BURLINGTON DEVELOPMENT REVIEW BOARD

Tuesday, May 4, 2021, 5:00 PM

TO: Development Review Board
FROM: Scott Gustin
DATE: May 4, 2021
RE: 20-0824SN; 3090 North Avenue

Request: Install information kiosk in flood hazard area.

2 SOUTH ELEVATION
A21 SCALE: 1/4" = 1'-0"

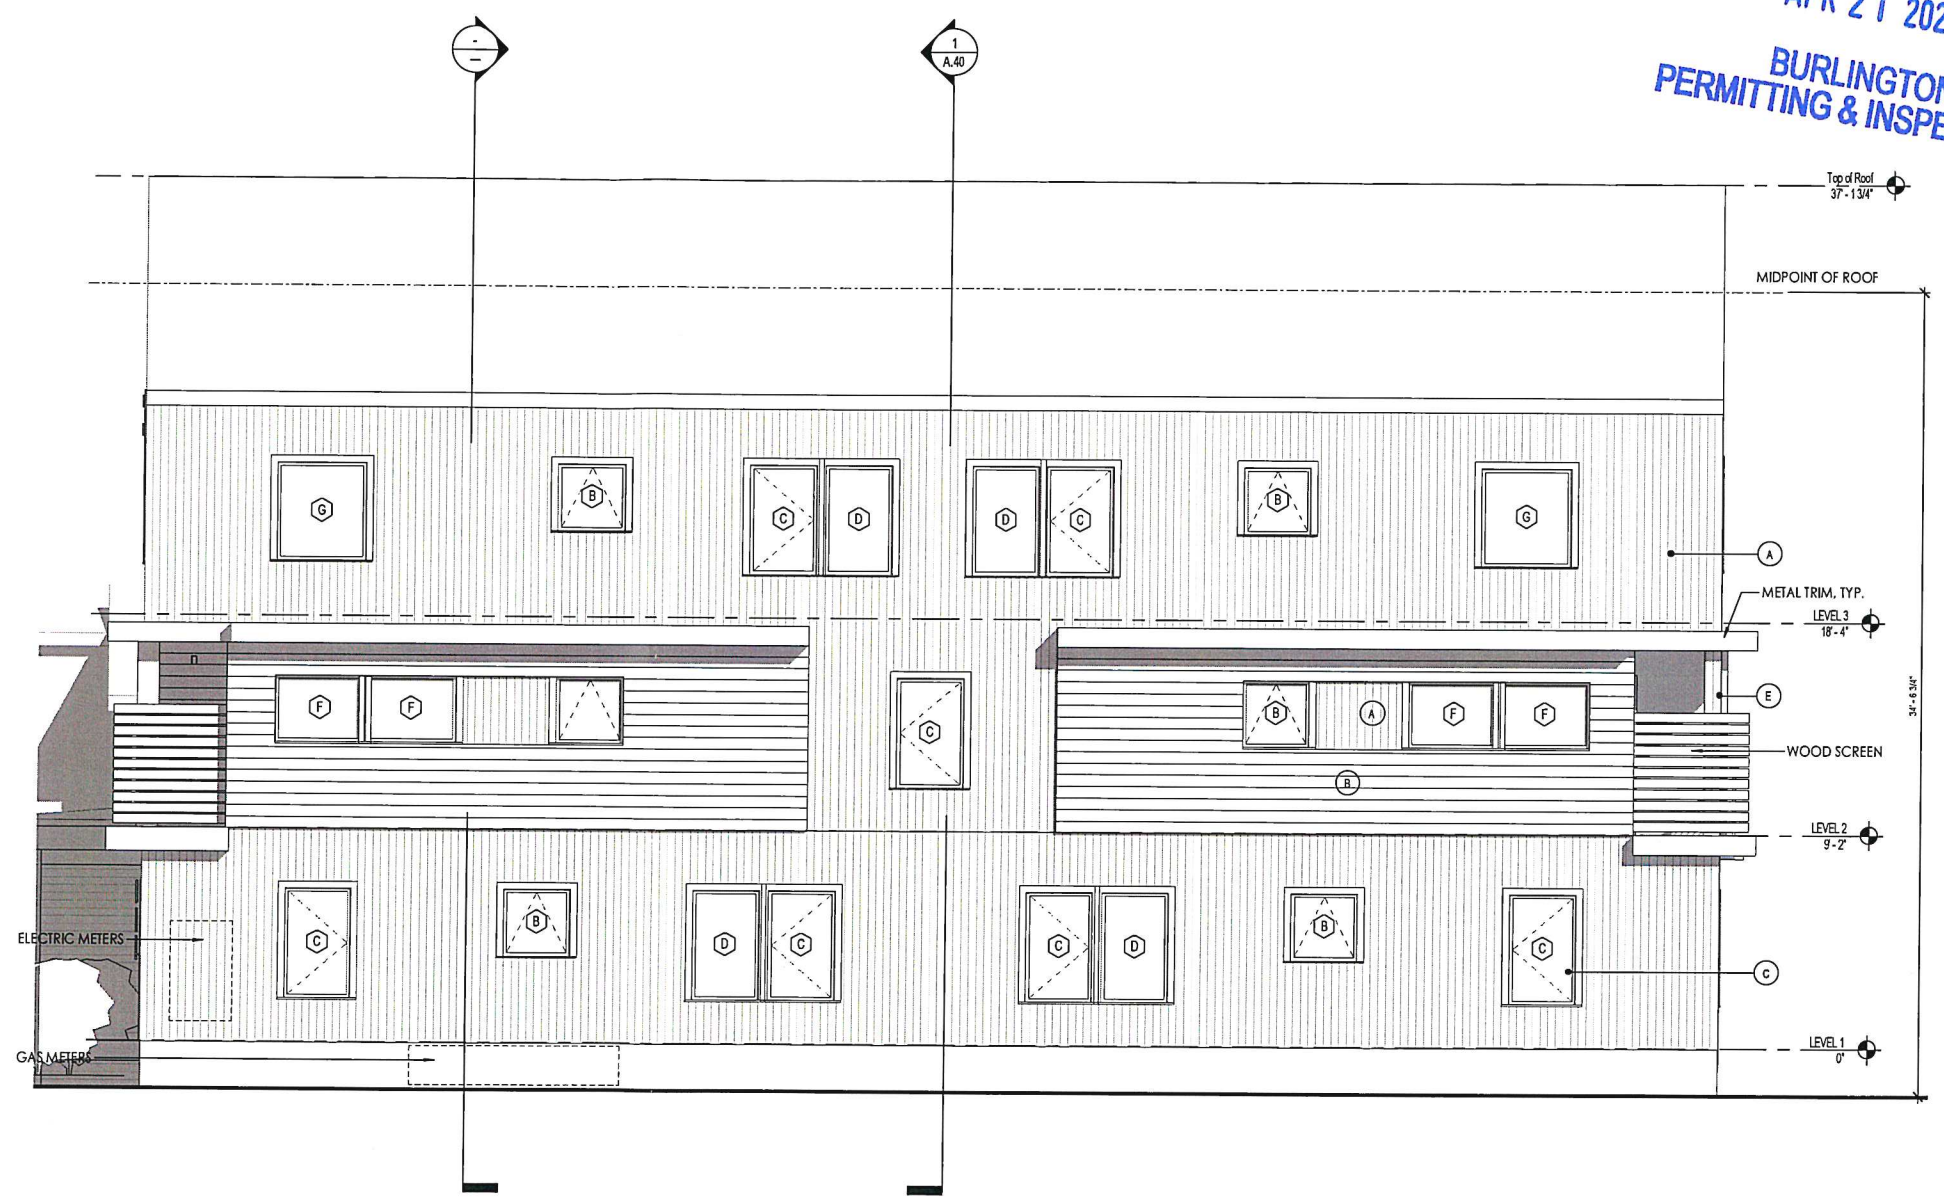
1. Remove the signage at the third story level;
2. Include a solar layout on the south facing roof; and
3. Add snow guards to the roof.
